TECHNICAL SERVICE BULLETIN

Popping Or Snapping Noise When Opening And/Or Closing The Liftgate - Built On Or Before 6-Mar-2019

19-222420 August
2019**Model:**

Ford 2019 Edge

Figure 1

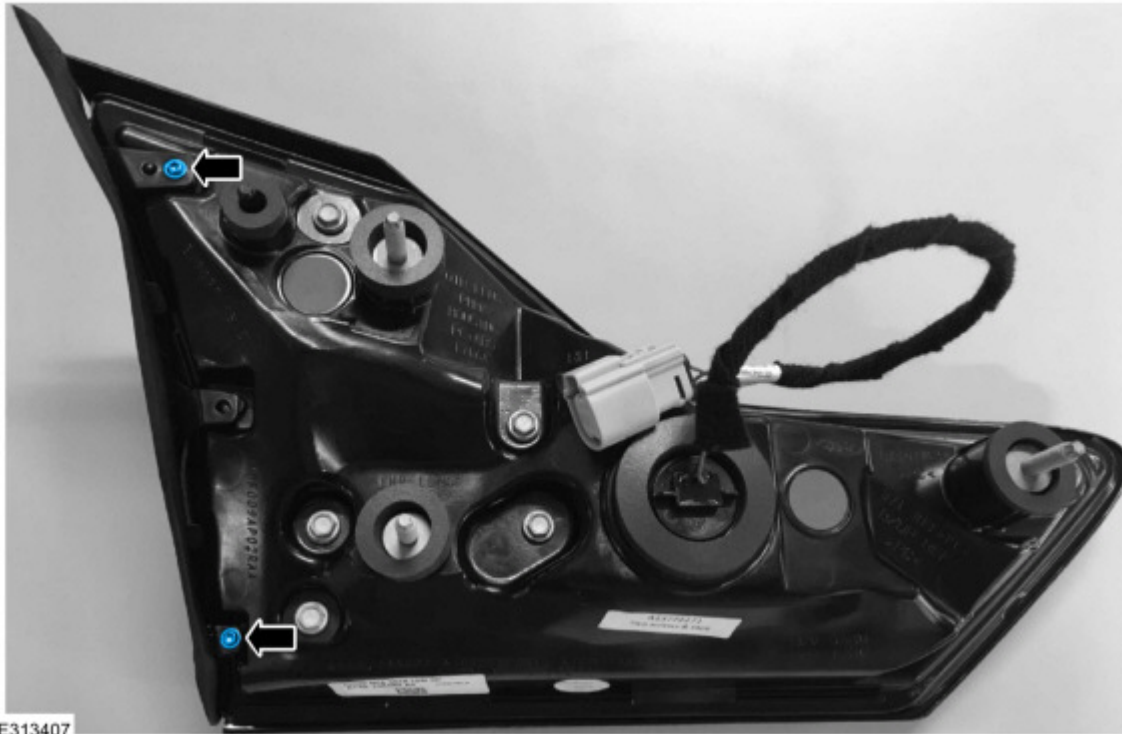
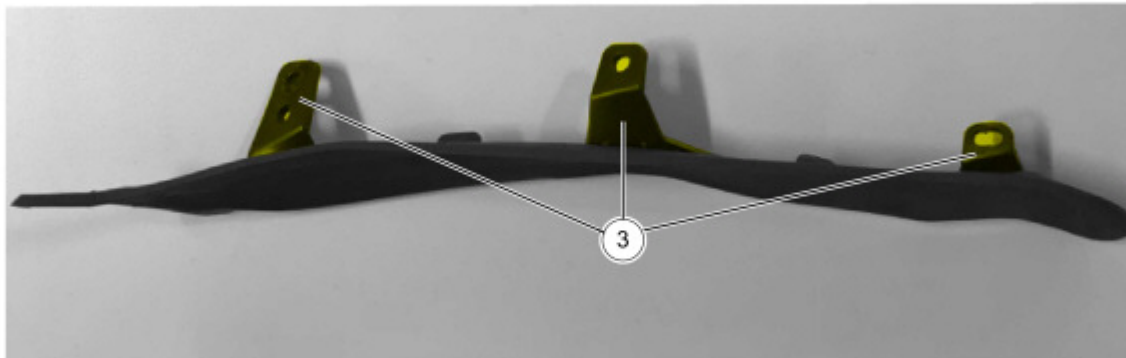
Issue: Some 2019 Edge vehicles built on or before 06-Mar-2019 may exhibit a popping or snapping noise from the rear of the vehicle when the liftgate is opened or closed. This may be due to reversing lamp close out interference caused by the securing tabs. To correct the condition, follow the Service Procedure steps to replace the reversing lamp close out. A lower level service part has been released. Replacement of the reversing lamp assembly is not required.

2. Using a Torx® T10 bit, unscrew the 2 reversing lamp close out screws and discard the 3 tab close out. (Figures 1-2)

Figure 3

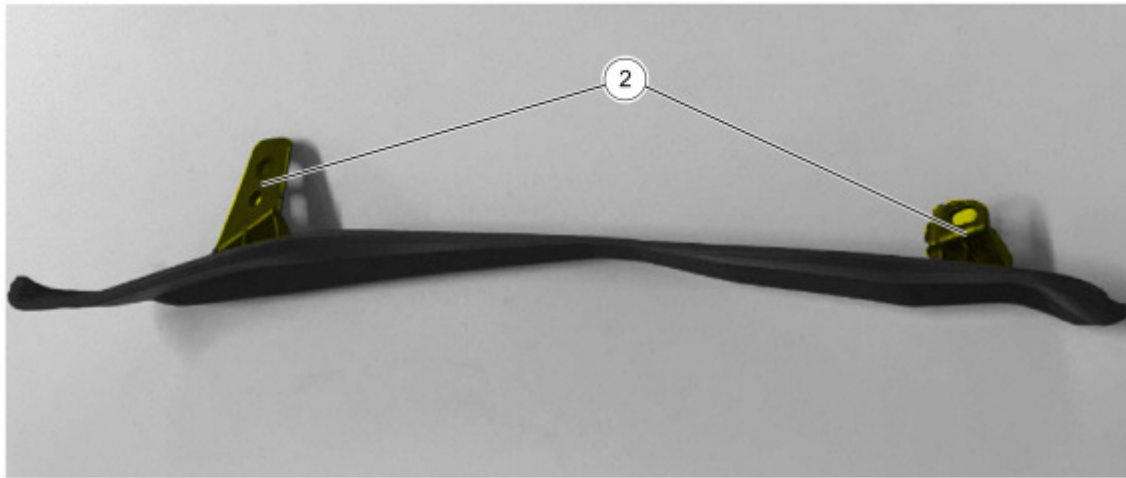
NOTE: The close out being removed will have 3 tabs and the new part will have 2 tabs. This is design intent of the new part.

3. Install the 2 tab reversing lamp close out and tighten to 1 Nm (8.85 in-lbs). (Figure 3)
